**Skilled Nursing Care / Mental Health Unit /
HIV – AIDS Unit and Renovation of Related
Support Facilities for
ELAYN HUNT CORRECTIONAL CENTER
LA State Project No. 08-413-97B-1, Part 7**

Addendum No. Three

ADDENDUM INFORMATION CIVIL
ELAYN HUNT SKILLED NURSING FACILITY
State Project No. 08-413-97B-1, Part 7
F&T Job No. 84637

SUB-SURFACE DRAINAGE PLAN

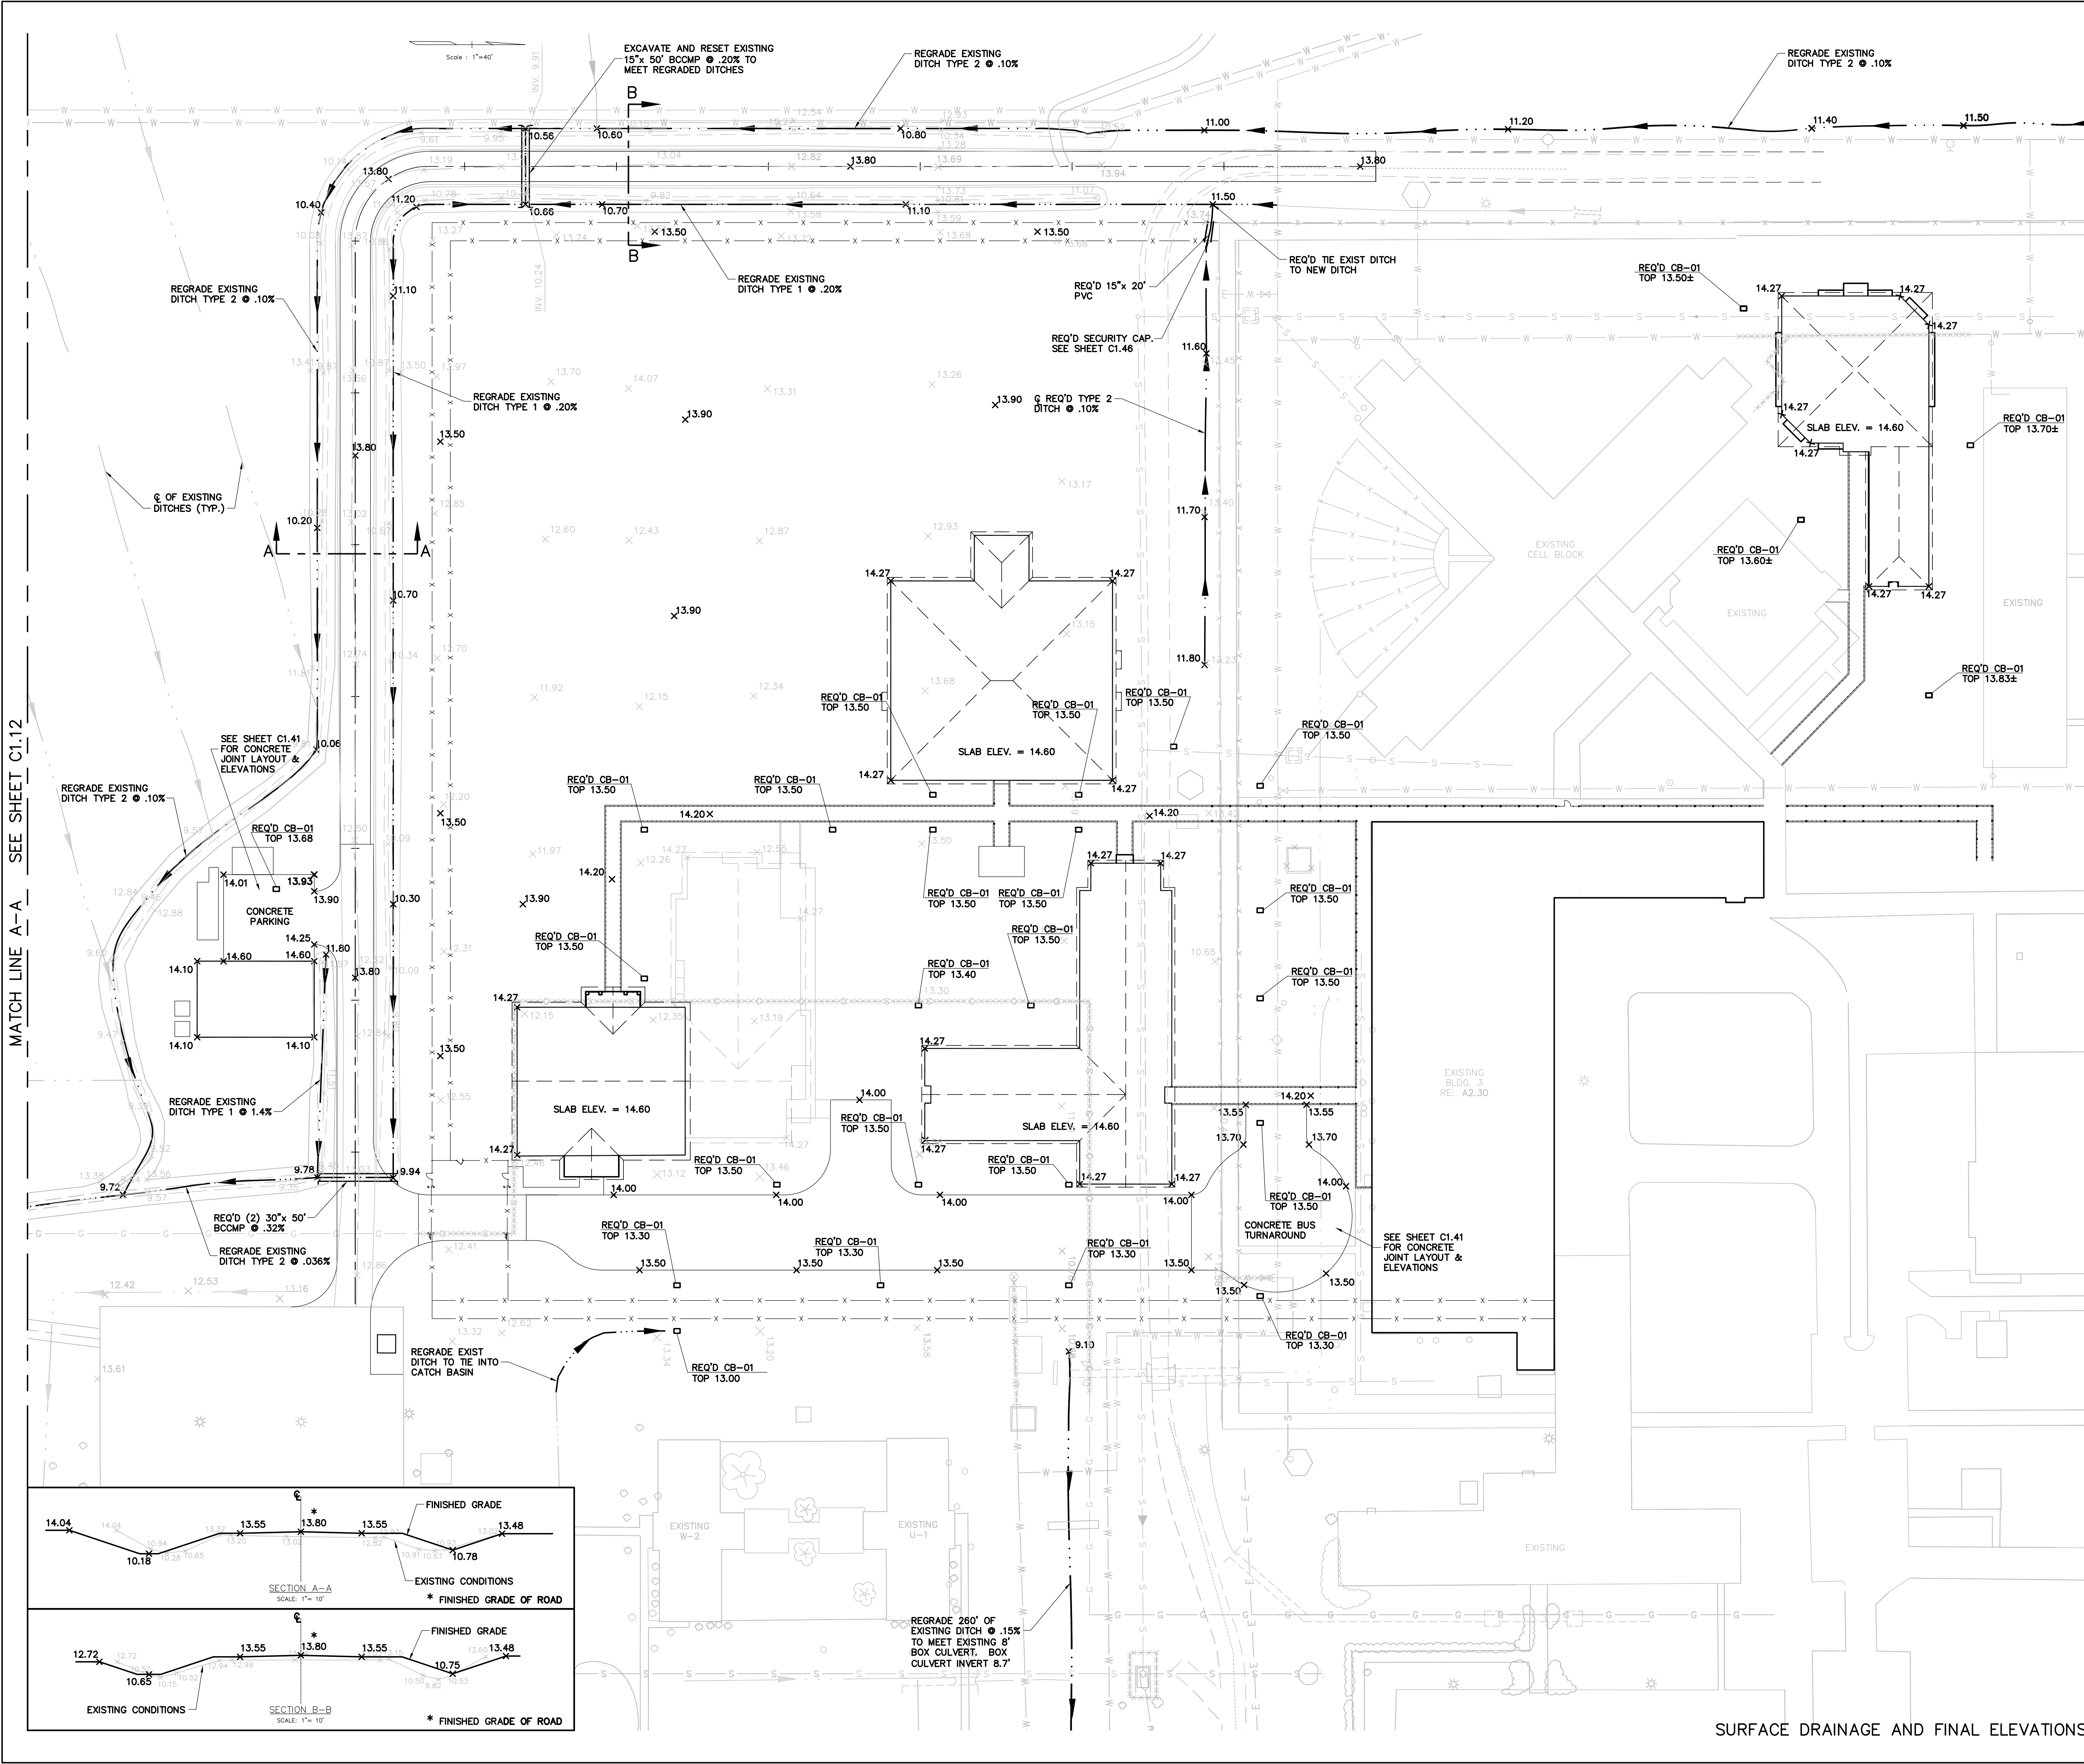
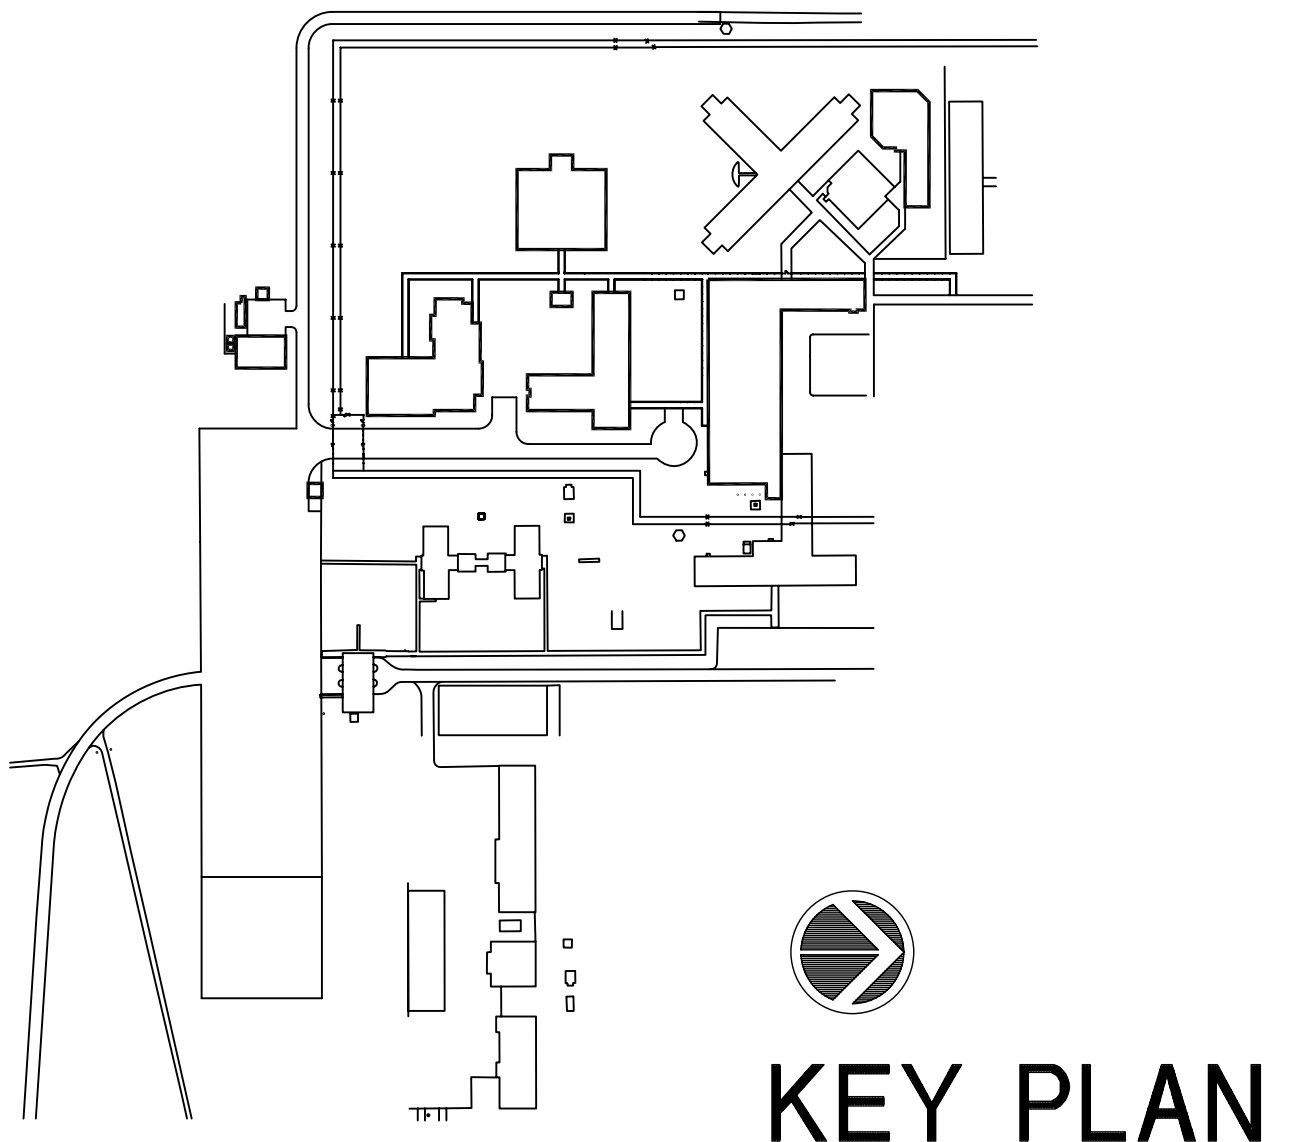
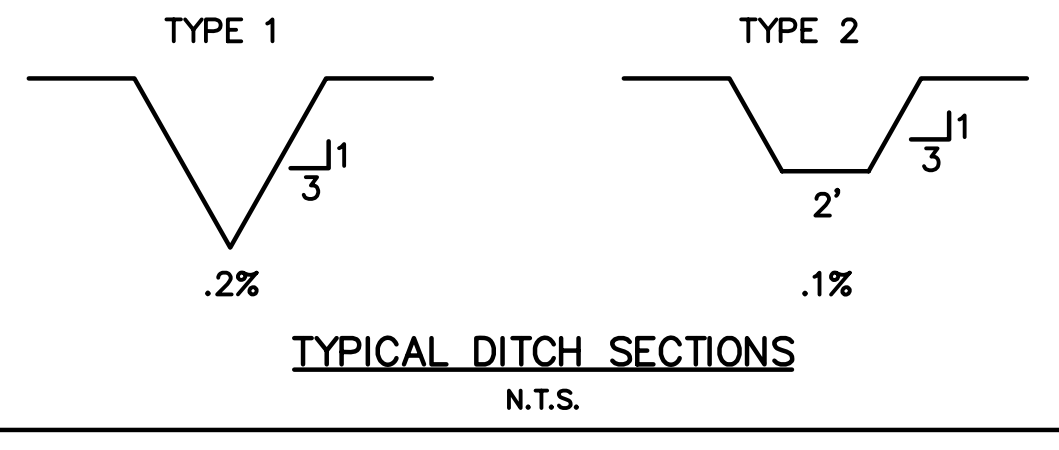
DRAWING C1.10

Insert Revised Drawing C1.10 (Revision 2, 05/27/05)

1 OVERALL SITE PLAN
EXISTING SCALE: 1" = 40'

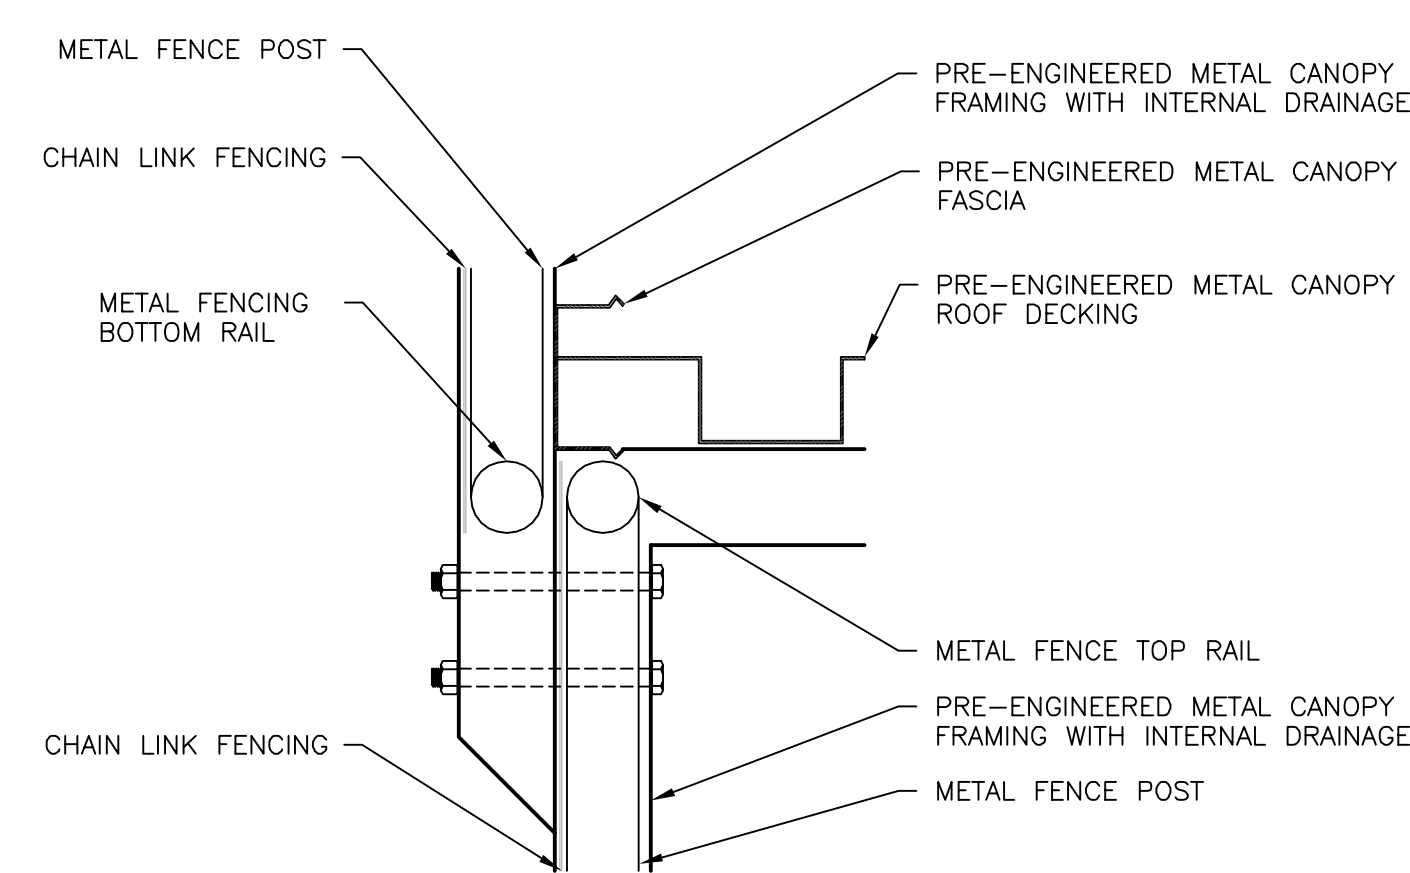
- 2) The thickness of the concrete canopy slab is 4". See attached revised A1.03 for dimension/scale clarification.
- 3) The concrete slab at the fence is a walkway 12'-0" wide as indicated on 11A1.03. See attached for clarification. The perimeter fencing is 12'-0" as indicated on 1A1.01 and referenced on A1.00. See attached for clarification.
